# Access Compliance Report

## Public Rights-of-Way

### (Curb Ramps)

Intersection ID: N/A	Main Street: PERIMETER_PY	Cross Street: N/A	Location: SE
ADA ID: C5CC182CAC14	Ramp Type: PerpDiag	Initial Pass/Fail: Pass	Overall Compliance: No
Severity Score: 10.25			
Codes/Mitigation Info/Possible Solution		Field Measurements/Component Compliance

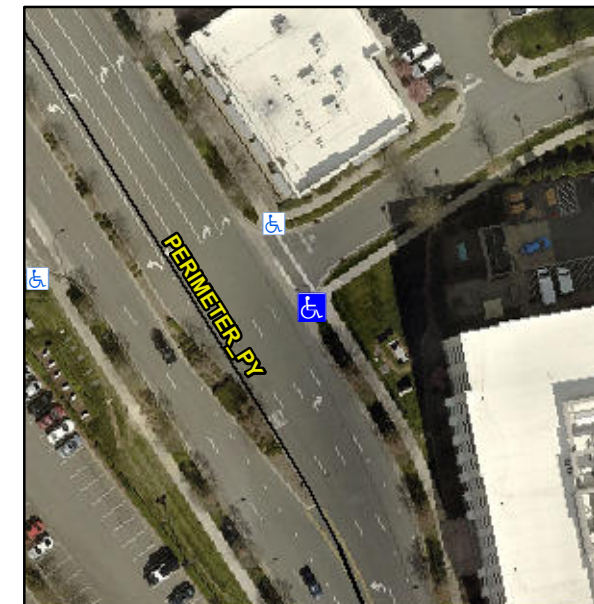
**Remove & Replace Curb Ramp With Two New Directional Ramps or Equivalent. Remove & Replace Gutter.**

**Not Found, R304.5.3, R304.2.1, R304.2.2-Perp, R304.3.2-Para**
